**MEETING OF THE
PLANNING AND ZONING BOARD
QUASI-JUDICIAL PUBLIC HEARING**

February 21, 2017

**TOWN OF BAY HARBOR ISLANDS
COMMUNITY DEVELOPMENT
MEMORANDUM**

Subject: Site Development Plan Application
 30 DU Multi-Family Residential Complex
 9880-9900 W. Bay Harbor Drive
 Bay Harbor Islands Acct. No. MB2016-142
 MMPA Acct. No. 01-0702-1044

PREVIOUSLY APPROVED DESIGN

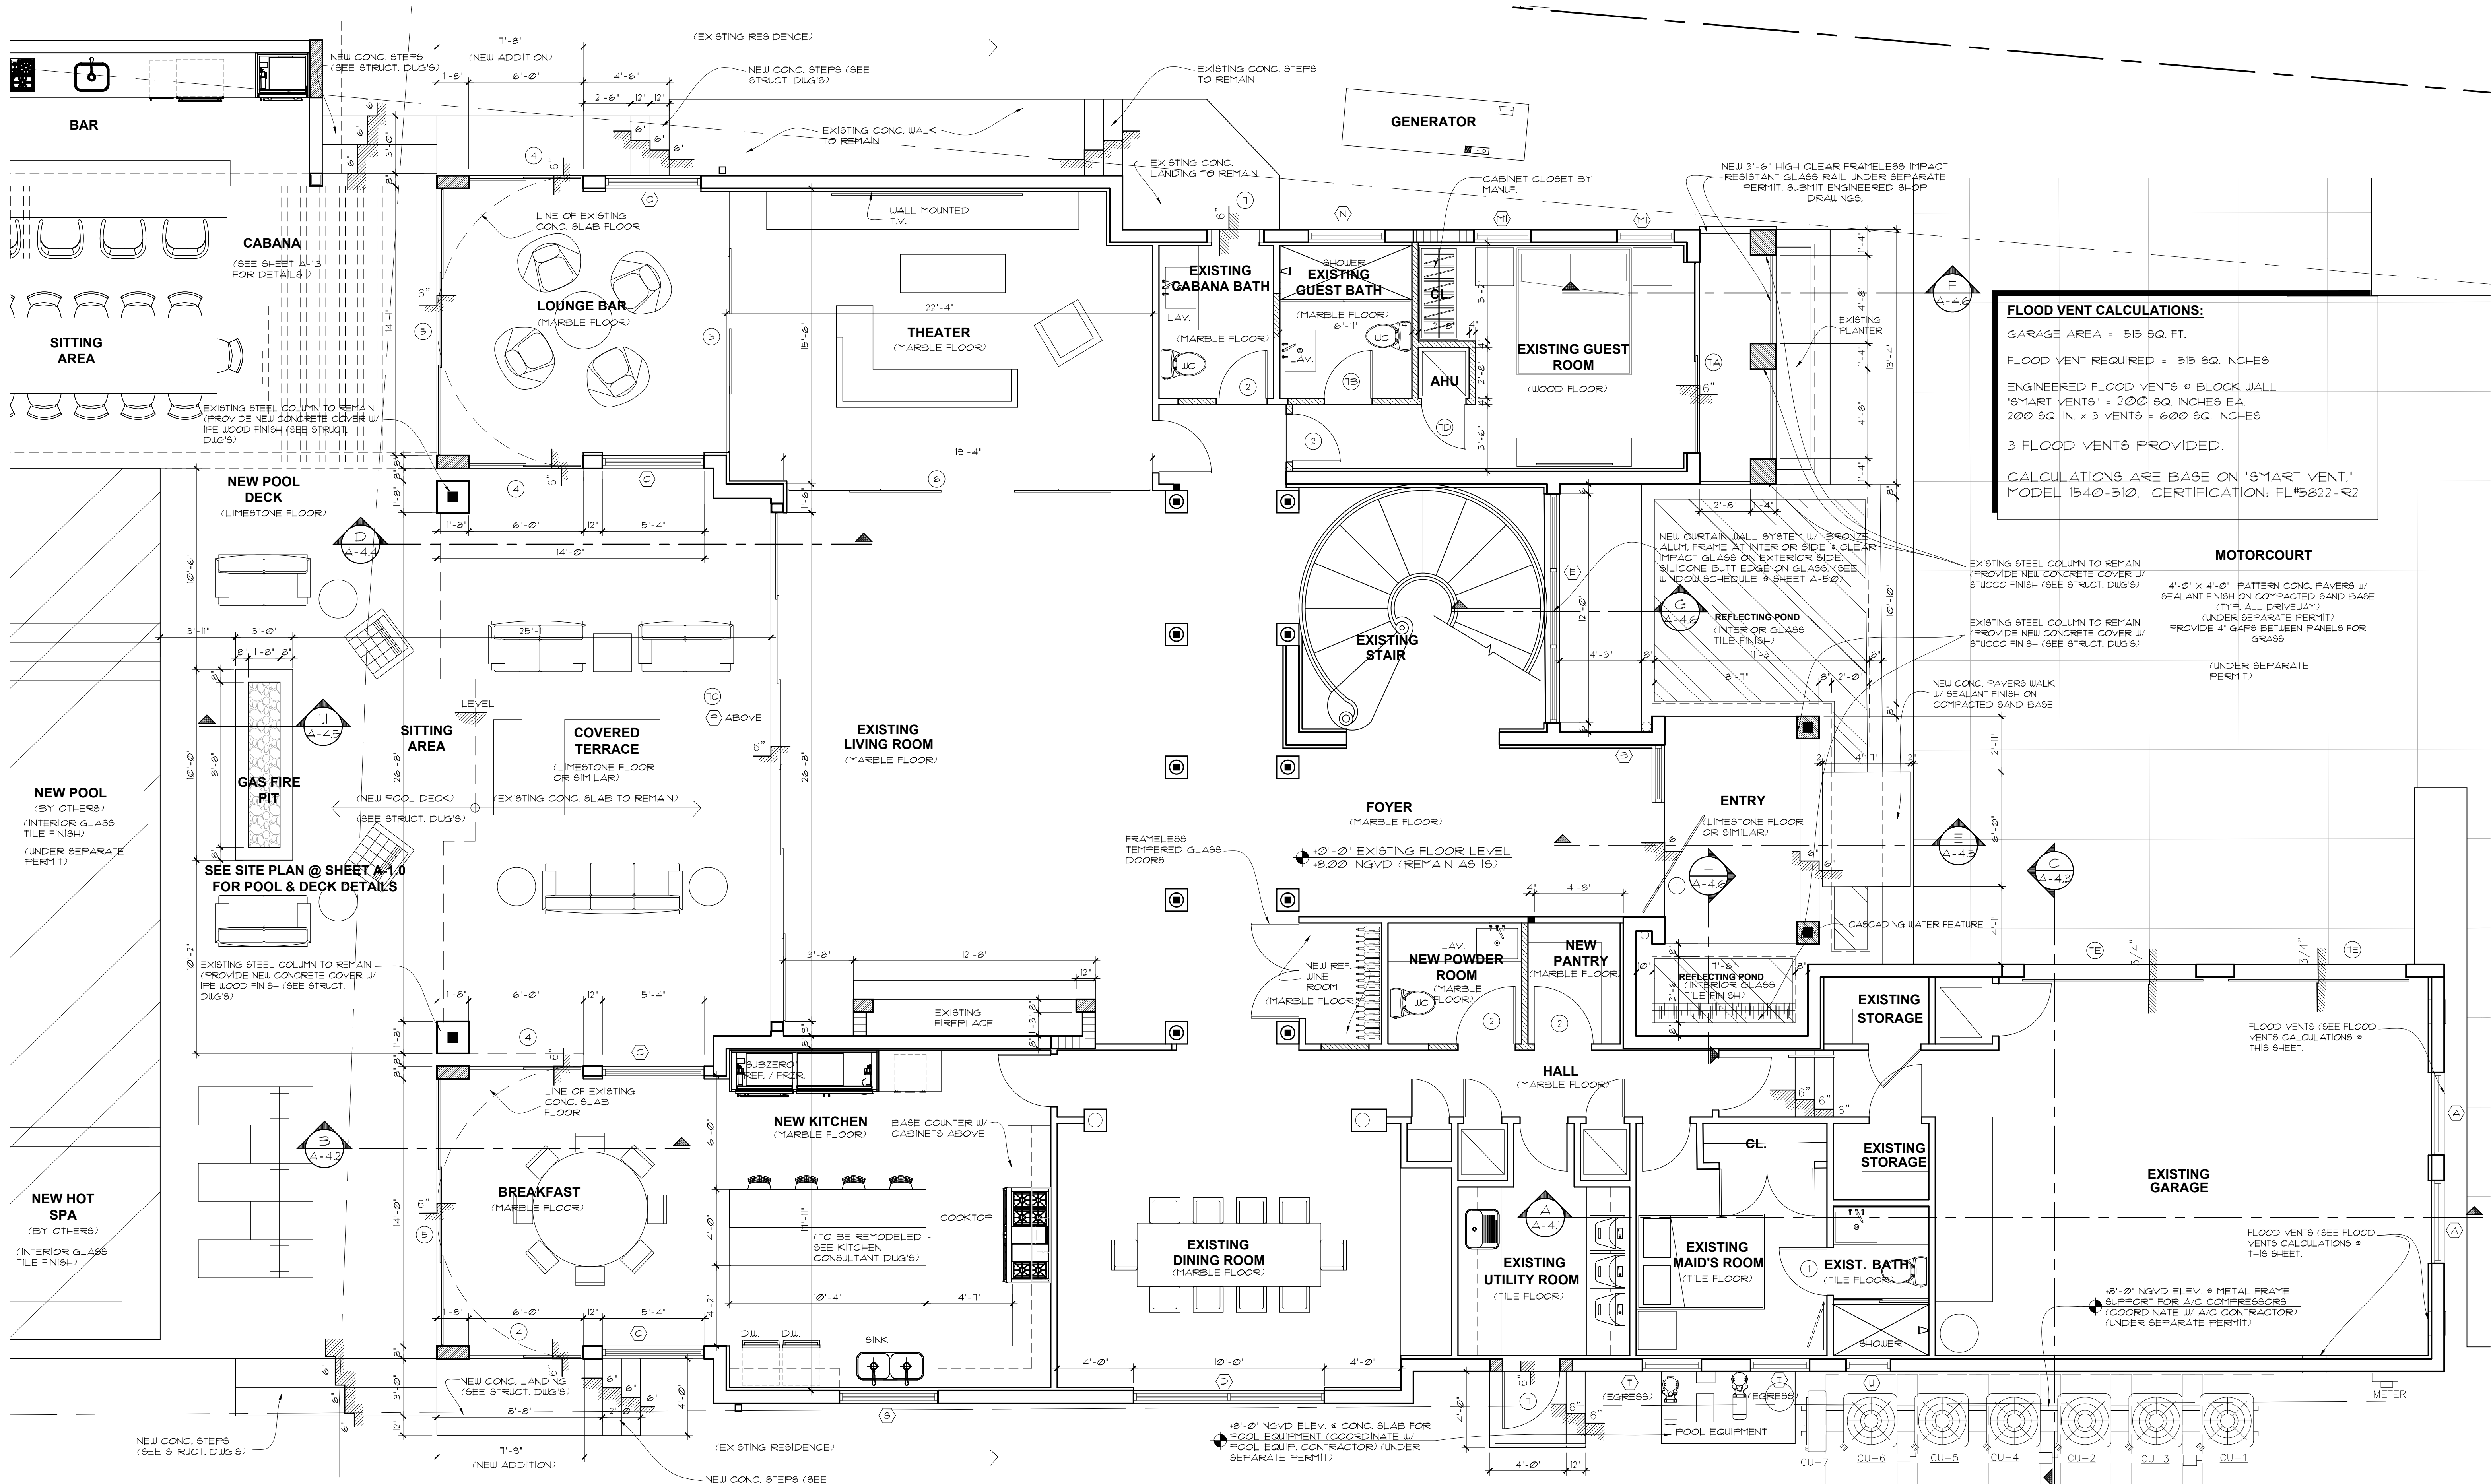
- 1) The applicant is now proposing to enclose the existing two-car garage for a "future interior space". The garage doors will be filled in and windows added. The previously approved stone material is also proposed to be replaced with smooth stucco. **PZB approval is requested for the proposed change.**
- 2) The applicant is proposing to modify the previously approved front entry design. The proposed design will be a thin roof overhang rather than the previously approved walkthrough structure. **PZB approval is requested for the proposed change.**

- 3) The applicant is requesting to add what they are calling a "portico" structure in front of the existing garage / proposed interior space, which will cover 2 parking spaces. **PZB approval is requested for the proposed change.**

There are specific setback and size limitations of such structures, that the plan does meet. The PZB must determine if the proposed "portico" structure meets the intent of the Code.

The Town Code defines "porticos" as a structure to cover a vehicular drop-off area near the main entrance. MMPA believes this structure is simply a "carport" which we feel is not listed as a permitted use. MMPA does not believe this structure meets the intent of the Code. The Board does not have the ability to "interpret" Zoning Code provisions. The PZB should discuss this and if necessary request the Town Council to clarify the issue and possibly modify the Code.
